**ADDENDUM NO. 1**

PROJECT TITLE: Re-Roof For:  
Beebe Readiness Center  
Military Department of Arkansas  
Beebe, Arkansas

DATE OF ISSUE: November 9, 2016

4. Drawings: Sheet A101 – UPPER ROOF PLAN, LOWER ROOF PLAN

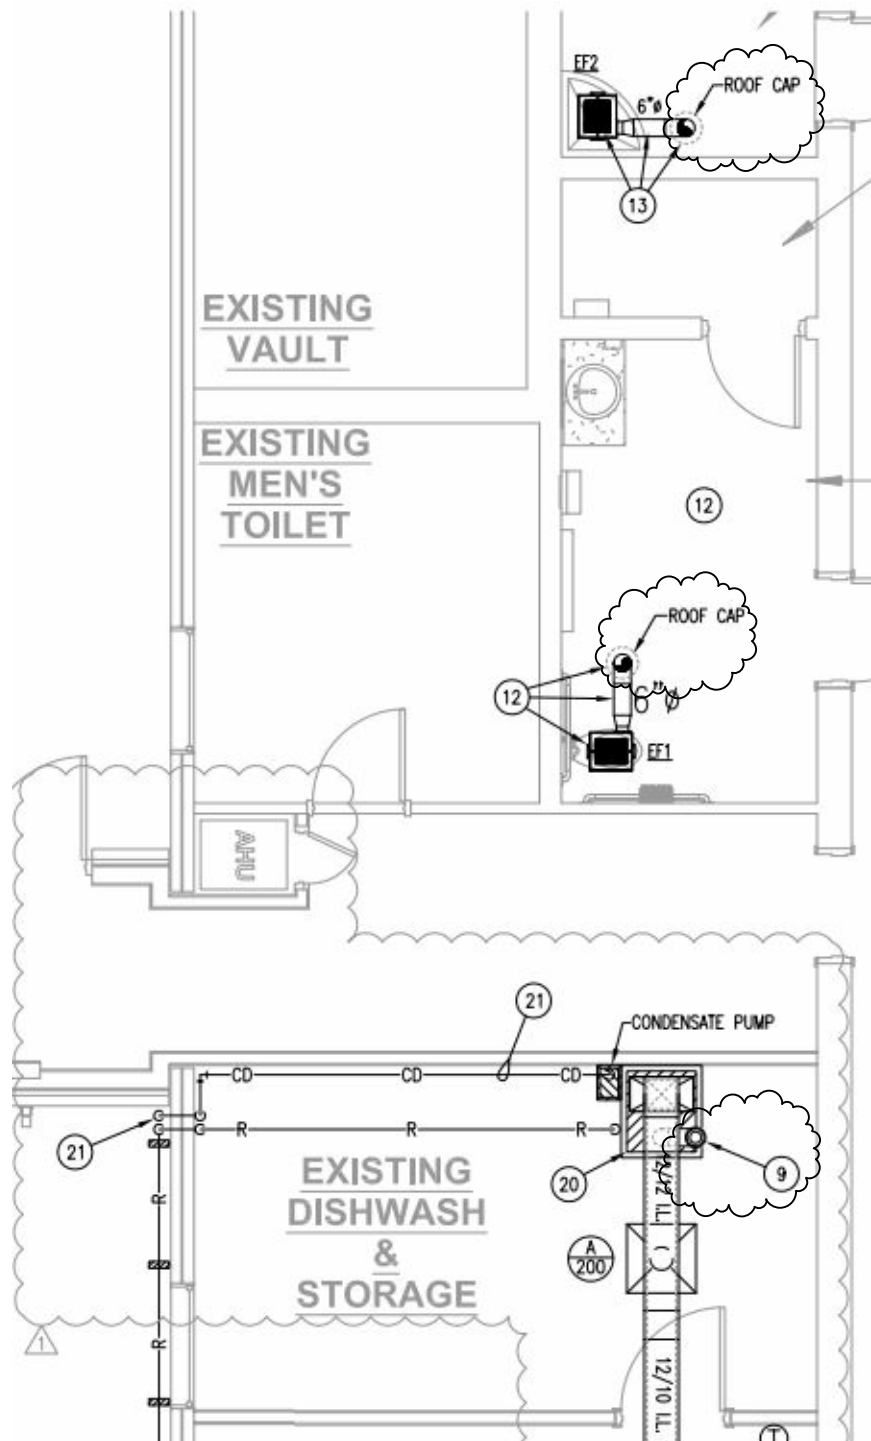
- A. Three (3) additional penetrations through the roof will be included in the scope of work for this project. Included is a drawing with locations of these penetrations. The proper flashing and continuation of these penetrations will be the sole responsibility of the contractor. Refer to page 4 of this addendum.
